TECHNICAL BULLETIN

<p>JAGUAR SERVICE</p>	<p>RECALL R469 – Hood Liner – Change of Specification – Replace</p> <p>MODEL 1994 MY XJ12 VIN 673299-708757</p> <p>DATE 1/99</p>	<p>76-128 Amended 3/99</p>
--	---	---

Remove and destroy Bulletin 76-128, dated 1/99.
Replace with this Bulletin.
Revisions are marked with a bar and in **bold text**.

ILLUSTRATION 1

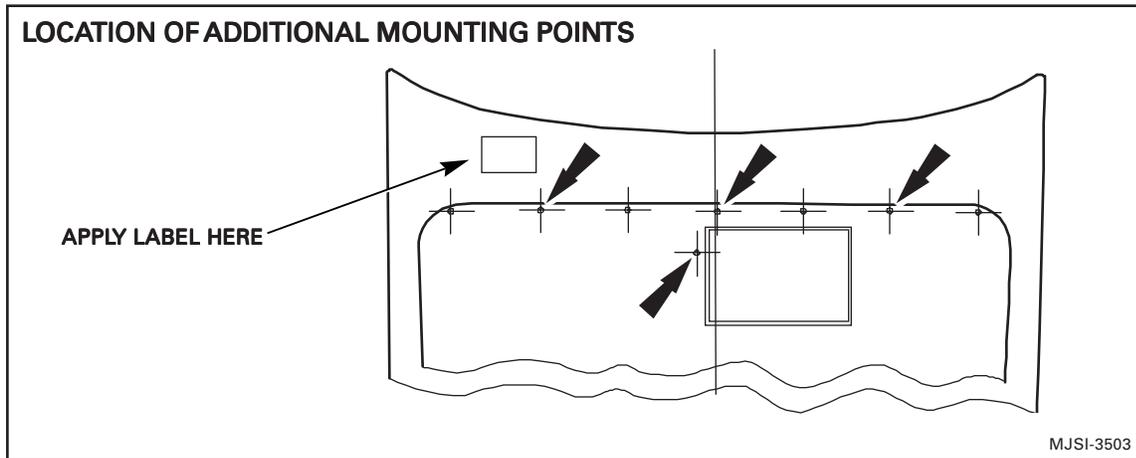
1. Check the **underside of the hood** for an R469 authorized modification label (**Illustration 1**). If no label is found, remove the existing hood liner. Save the screw fasteners for reuse. On vehicles equipped with twin engine compartment lamps, unclip the lamps and disconnect them at the adjacent multiplug connector. The lamps can be discarded. Ensure that the unused harnesses remain attached to their support clips, to avoid rattles. If a clip is missing and a replacement is not available, wrap the multiplug connectors with soft foam, secured by adhesive tape, so that they will be held against the metal by the replacement liner.
2. Peel off the protective backing from the replacement hazard warning label.
3. Carefully align the label with the aluminum foil patch on the replacement liner and adhere the label to the foil.

5. Refer to Illustration 1 for the location of the 4 **additional** fasteners.
6. Use a scribe to mark through the locations of the **additional** fastener points on the ribs of the hood reinforcement panel.
7. Remove the replacement liner. Temporarily place the old liner over the engine, to catch any drill chips from the following operations.
8. Center punch the reinforcement panel at the centers of the locations marked in step 6 above. Check that the locations line up approximately with the centers of the raised ribs of the reinforcement panel.

4. Position the replacement hood liner. Temporarily retain it in its correct position by installing 4 or 5 of the screw fasteners. Ensure that the liner is aligned with **all** existing fastener points - adjust if necessary.

ILLUSTRATION 2

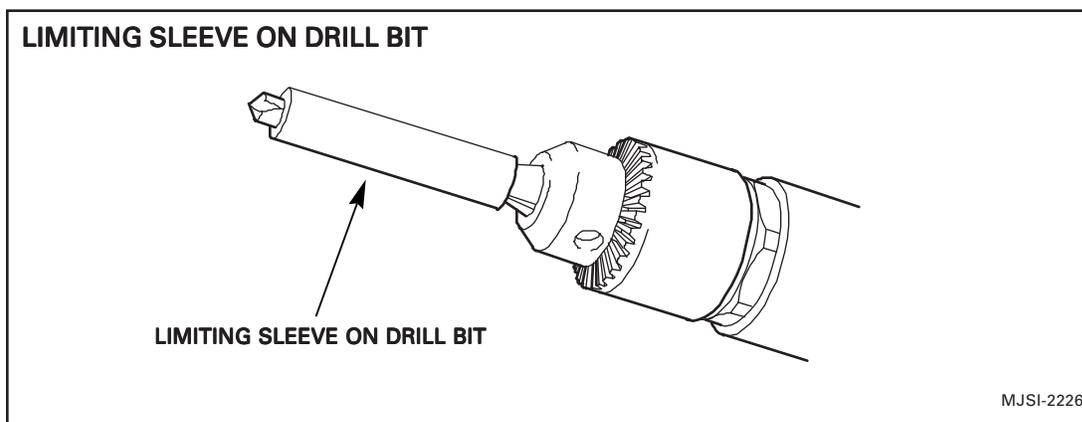
9. Use a drill equipped with a plastic or rubber sleeve (Illustration 2) to act as a stop so that the drill bit will not penetrate **more than 5 mm (3/16 inch)**, to drill a pilot hole at each of the 4 locations.

⚠ Caution: Careless drilling that allows excessive penetration of the drill bit can result in serious cosmetic damage to the outer panel of the hood.

10. Enlarge the 4 holes to 6.35 mm diameter (1/4 inch) using a drill bit similarly fitted with a depth limiting sleeve.
11. Clean away all chips from the drilling operations. Remove the old liner from covering the engine.
